**City of Portland, Maine – Building or Use Permit Application** - 389 Congress Street, 04101, Tel: (207) 874-8703, FAX: 874-8716

Location of Construction: <i>Summit &amp; Willis St., Great Diamond Island</i>	Owner: <i>Keely Maher</i>	Phone:	Permit No: <b>000810</b>
Owner Address: <i>1 Grove Pl., Melrose, MA 02176</i>	Lessee/Buyer's Name: <i>1 Grove Pl., Melrose, MA 02176</i>	Phone:	Business Name:
Contractor Name: <i>**Steven Berube</i>	Address: <i>28 Vaille St., Portland 04103</i>	Phone: <i>772-2541</i>	<div style="border: 2px solid red; padding: 5px; text-align: center;"> <b>RECEIVED</b>                  DEPT. OF CONSTRUCTION                  CITY OF PORTLAND, ME  <b>Permit Issued:</b>  <b>JUL 25 2000</b> </div>
Past Use: <i>Single House</i>	Proposed Use: <i>Single House</i>	<b>COST OF WORK:</b> \$ <i>60,000.00</i> <b>PERMIT FEE:</b> \$ <i>300.00</i>	
Proposed Project Description: <i>Build a 20 x 24 summer cottage</i>		<b>FIRE DEPT. INSPECTION:</b> <input type="checkbox"/> Approved <input type="checkbox"/> Denied Signature: _____	<b>INSPECTION:</b> Use Group: _____ Type: _____ Signature: _____

**CITY OF PORTLAND, ME  
BOCA 1999 Plan Review Record  
One and Two Family Dwelling**

Second floor plan

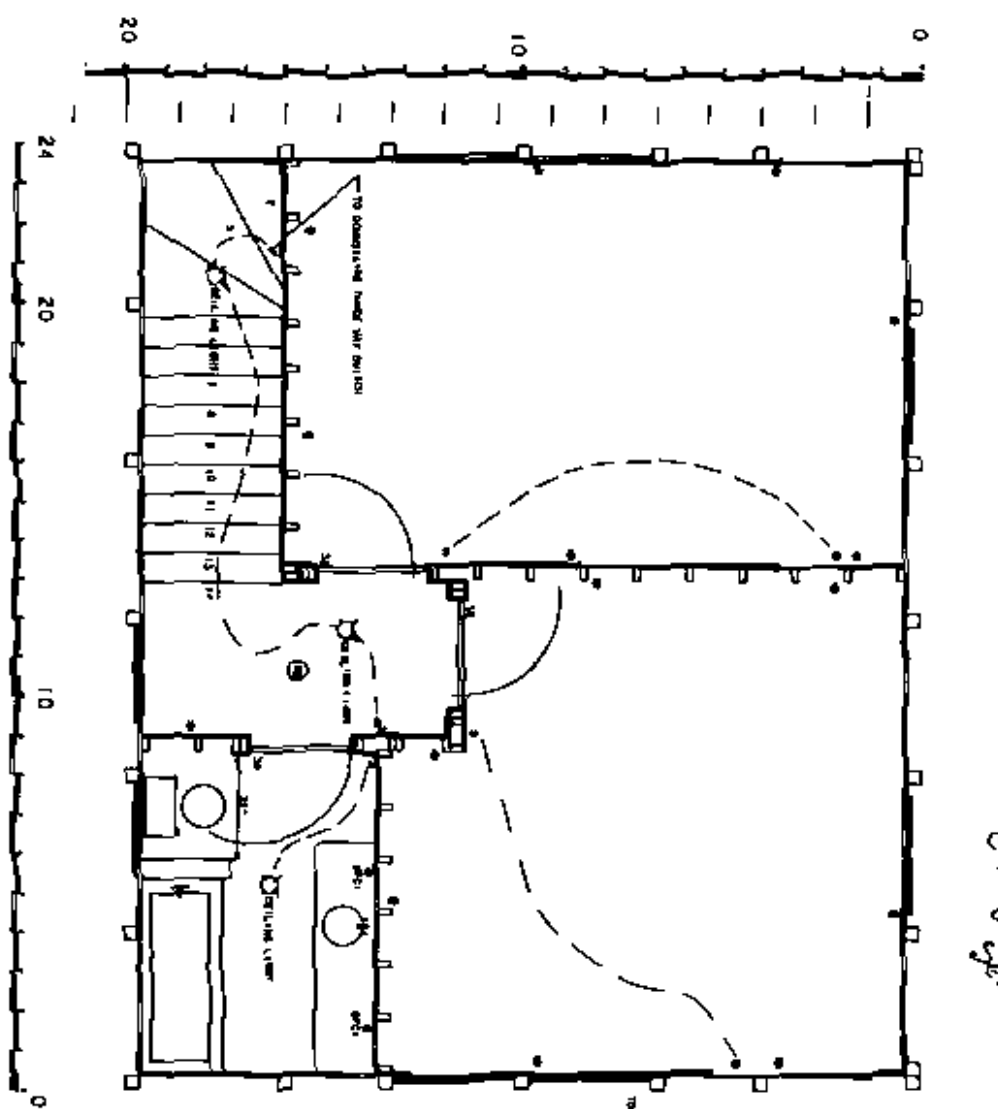
*Express or Resour  
Window  
Sec. 1010.4*
